# North Sheridan Interchange Agency Scoping and Public Meeting Summary

Prepared for WYDOT  
by HDR Engineering

October 2009

## Agency Scoping Summary

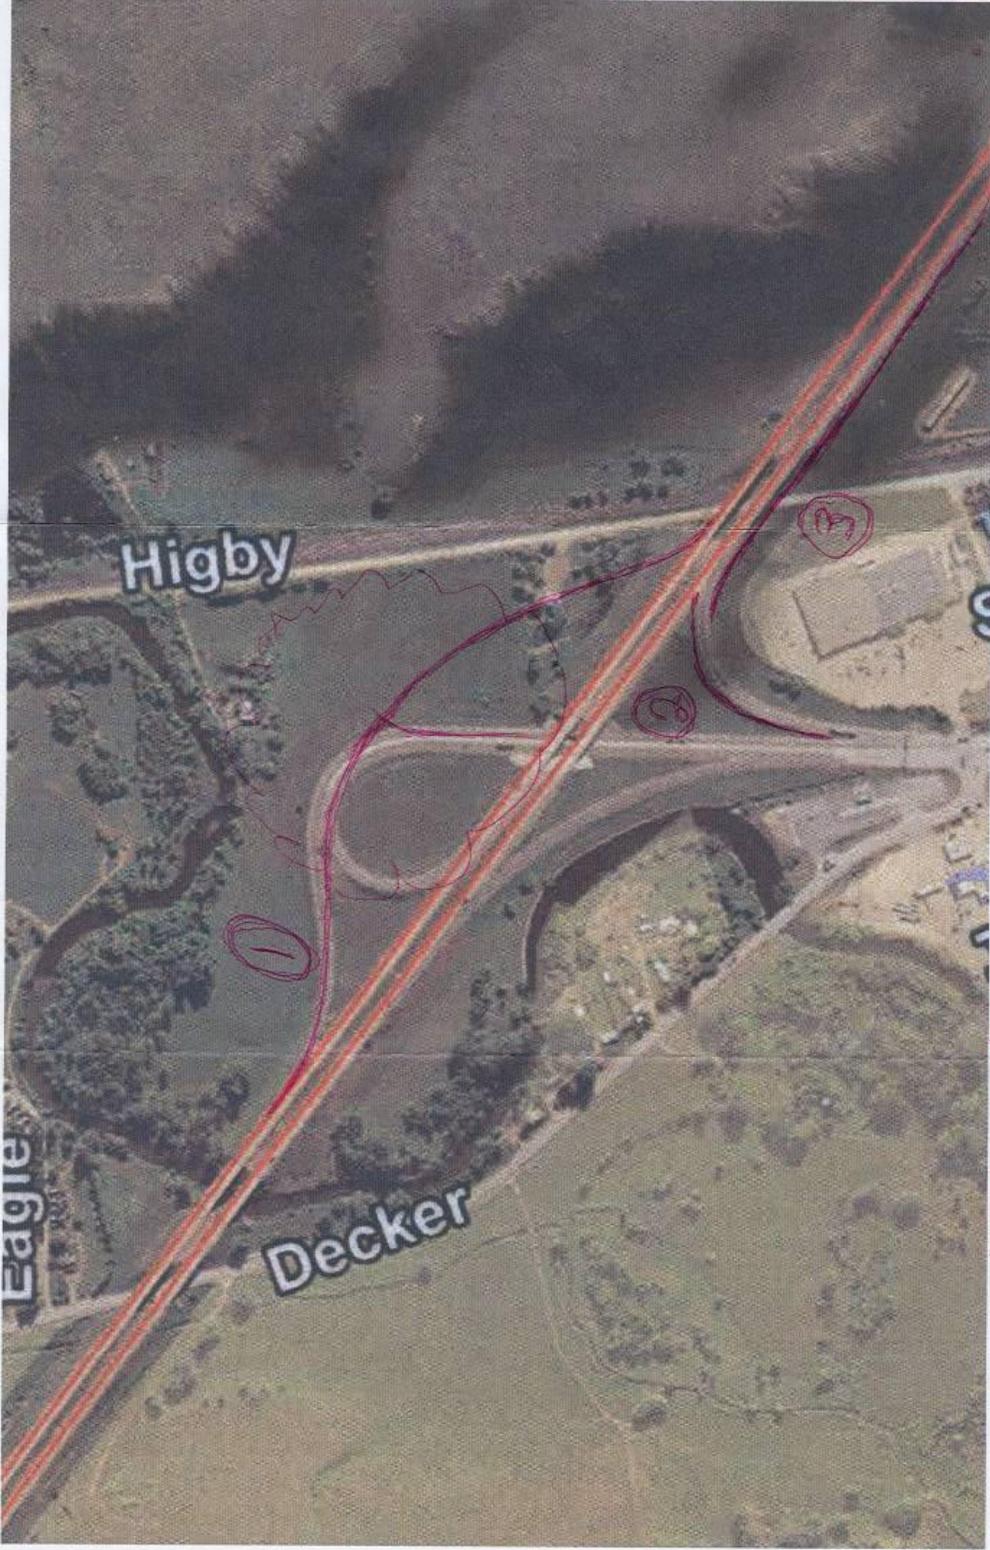
Attached is an engineered drawing (minimal cost) that could be used by any rancher to build this interchange.

① Add fill as required to elevate area to decrease 8% grade

② Add guardrail and warning lights  
③ Add acceleration ramp/lane
